***Planning Department  
Transportation Development Services***

**Re: Santa Fe Tow Lot #13  
8101 Jacs Ln., NE  
Traffic Circulation Layout**  
Engineer's/Architect's Stamp dated 11-17-15 (D16-D002A5)

SANTA FE TOW, ARMANDO BELTRAN — TRAFFIC CIRCULATION LAYOUT (TCL)

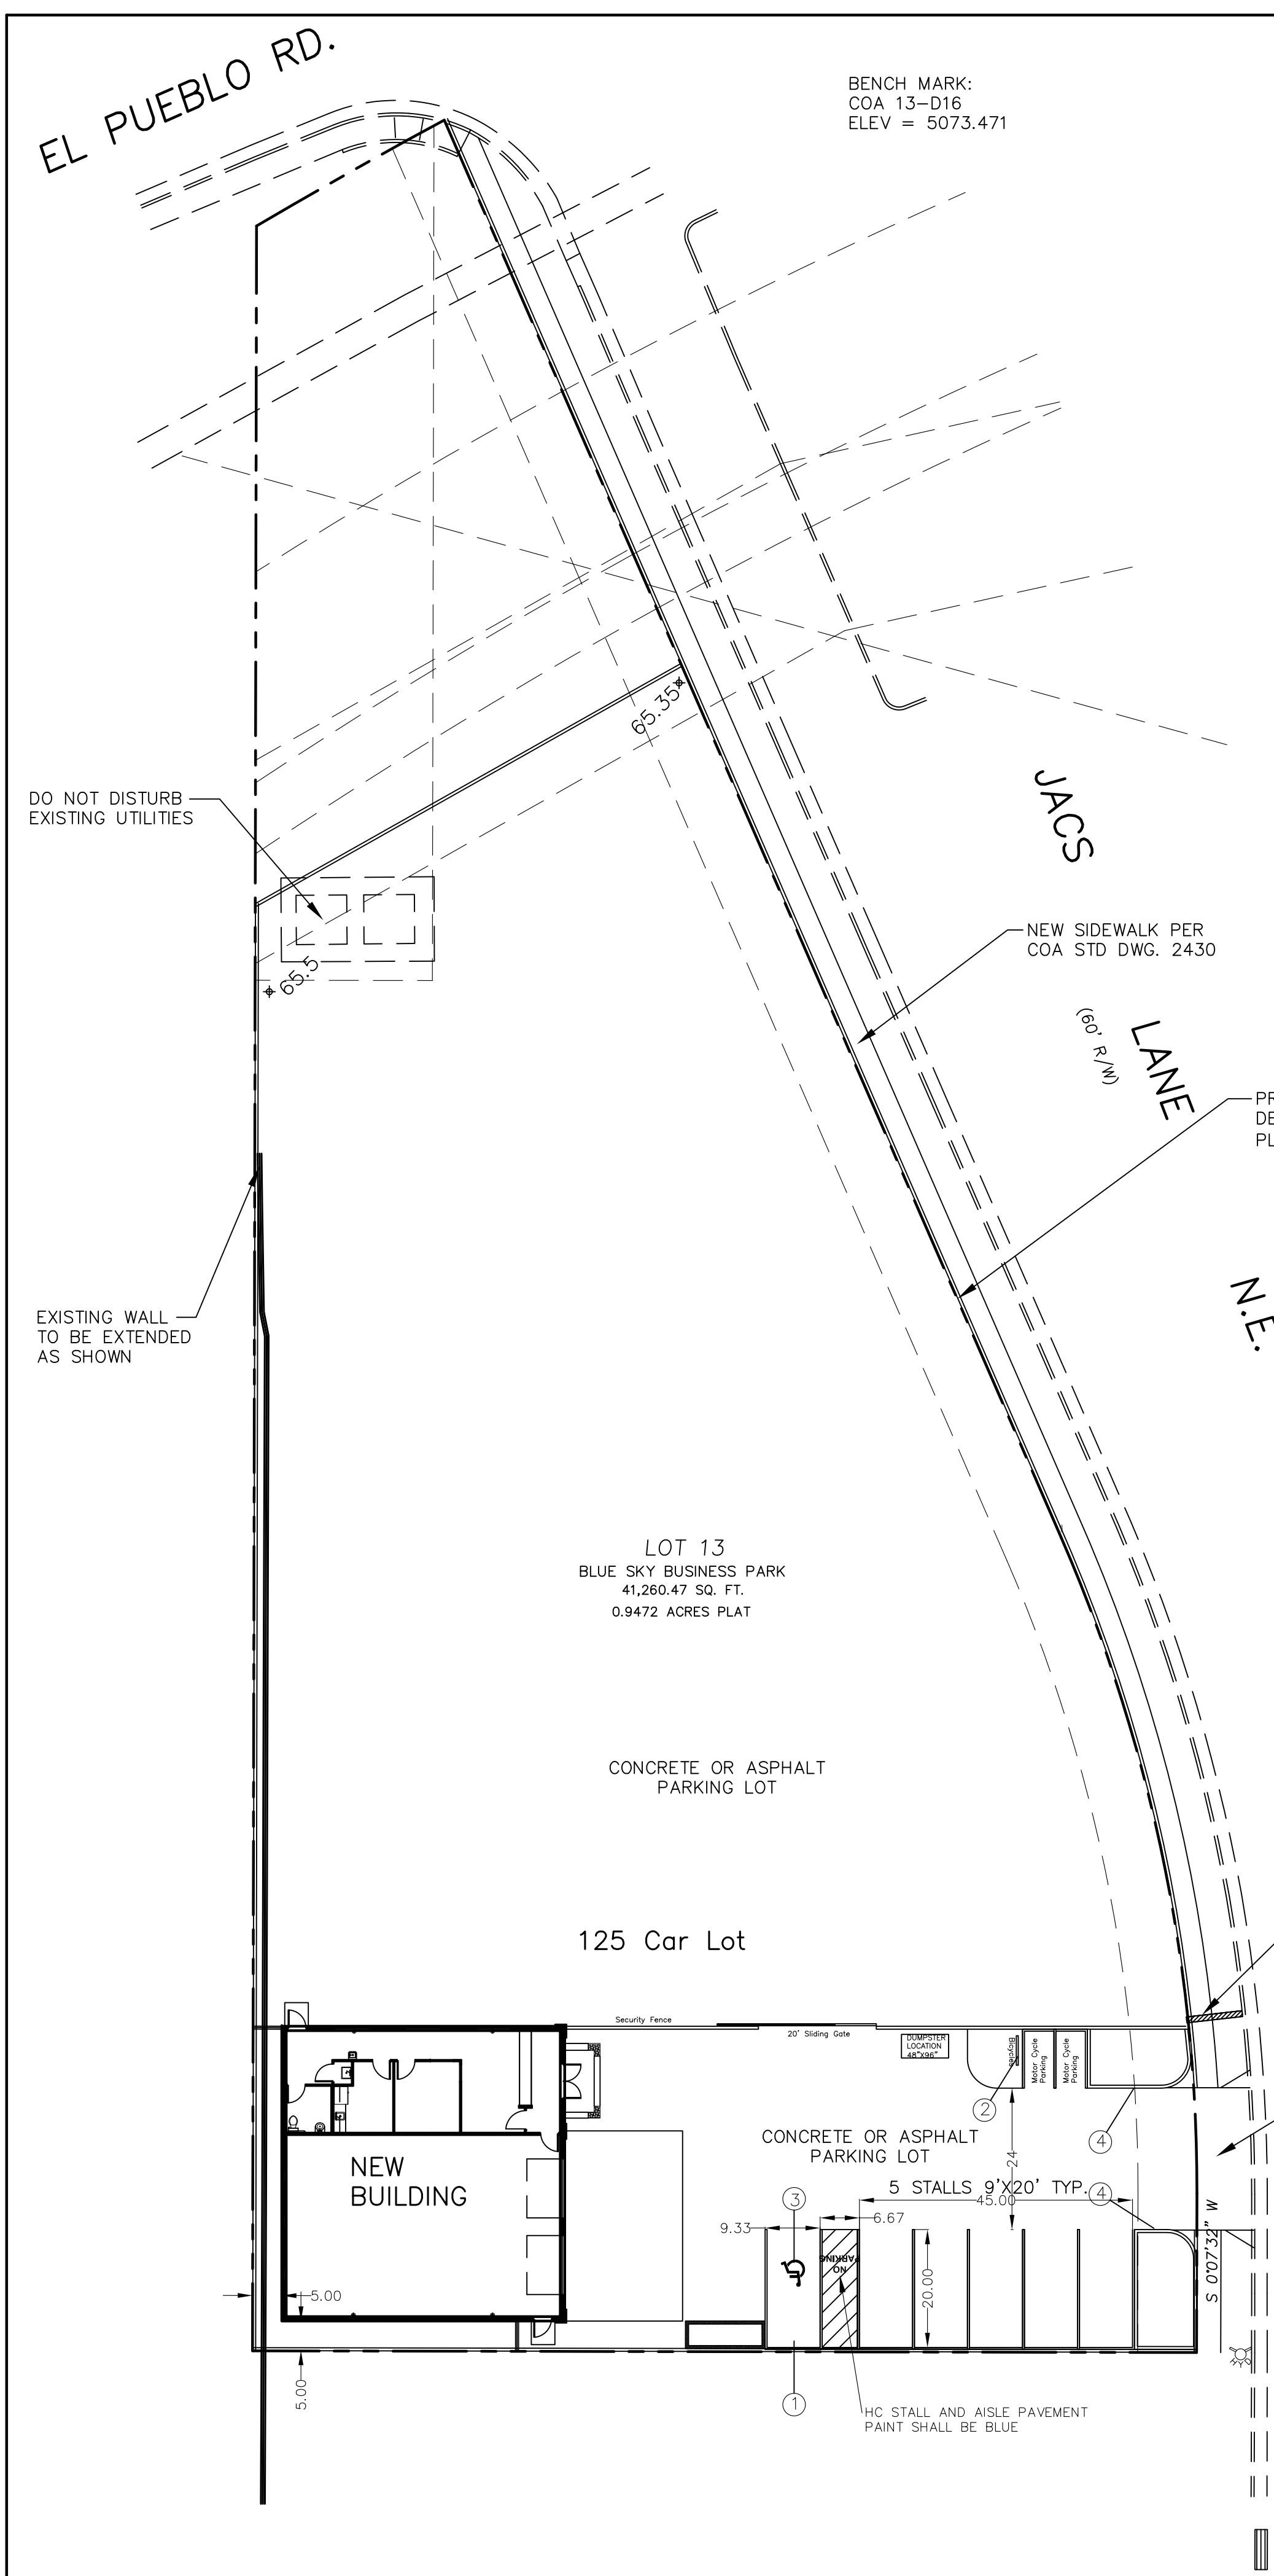
1. Please identify all existing buildings, doors, sidewalks, curbs, drive pads, walls and anything that influences the parking and circulation on the site.

2. Show all drive aisle widths and radii.
3. Please detail the width of the proposed drive pad.
4. Please detail the ADA ramps and sidewalk from the Public R.O.W.

5. Per the DPM, a 6 ft. wide ADA accessible pedestrian pathway is required from the public sidewalk to the building entrances. Please clearly show this pathway and provide details.

6. Per the DPM, a 6 ft. wide ADA accessible pedestrian pathway is required from the HC parking stall access aisles to the building entrances. Please clearly show this pathway.

7. Provide a min 6" or max 8" high concrete barrier curb or other acceptable barrier between landscaping and parking areas and/or drive aisles.
8. Design delivery vehicle route needs to be shown.

9. Service vehicle and/or refuse vehicle maneuvering must be contained on-site; provide a copy of refuse approval.

10. Please provide a sight distance exhibit (see the *Development Process Manual, Chapter 23, Section 3, Part D.5 Intersection Sight Distance*). Please show this detail for the entrance/exit on Jacs Ln.

11. Please add the following note to the clear sight triangle: "Landscaping and signage will not interfere with clear sight requirements. Therefore, signs, walls, trees, and shrubbery between 3 and 8 feet tall (as measured from the gutter pan) will not be acceptable in this area."
12. Please include two copies of the traffic circulation layout at the next submittal.
